**PRODUCT SUPPORT BULLETIN
BULLETIN NO. 284**

MACHINE: Model C Spike Driver

SUBJECT: Relocation of Gager Outer Cylinder Flow Control Valve

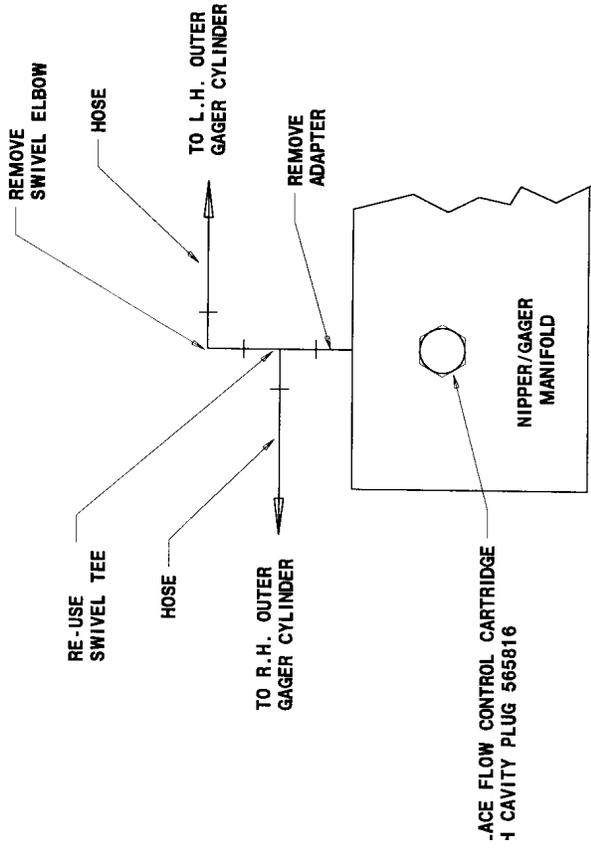
There have been some instances of the Outer Gager Cylinders slowing down when pulsing down to the rail in jointed mode. The slow movement is accompanied by a “squealing” sound. This problem usually shows up after about one hour of operation.

The problem is caused by location of the 28 gpm flow control valve which regulates oil into the cylinders. The current location can cause the outer cylinder pilot operated check valve to open and close at a rapid rate. Some of the oil then returns to tank through the 500 psi relief valve.

To solve the problem, the 28 gpm flow control valve must be relocated from its present position in the Gager/Nipper Manifold. A kit to relocate the flow control is available under part number R1026802. The price of this kit is \$115.00 and can be installed in about 10 minutes.

DISCONNECT THE OUTER GAGER CYLINDER HOSES AT THE MAINFOLD.

REMOVE THE TEE, ELBOW AND ADAPTER FROM THE MAINFOLD. SAVE THE TEE FOR RE-USE.

REMOVE THE FLOW CONTROL CARTRIDGE FROM THE ENGINE SIDE OF THE MAINFOLD AND REPLACE IT WITH THE CAVITY PLUG, 565816.

1. INSTALL ADAPTER 2076276 INTO THE TOP
2. INSTALL SWIVEL ADAPTER 2075865 INTO FLOW CONTROL CARTRIDGE BODY 566113. INSTALL ADAPTER 207626; REMOVE THE VALVE BODY. INSTALL THE FLOW CONTROL CARTRIDGE REMOVED FROM THE MAINFOLD INTO THE HOUSING OF THE HOUSING.
3. INSTALL THE TEE WITH THE BRANCH OF THE TEE TOWARD THE ENGINE. RECONNECT THE HOSES BELOW.
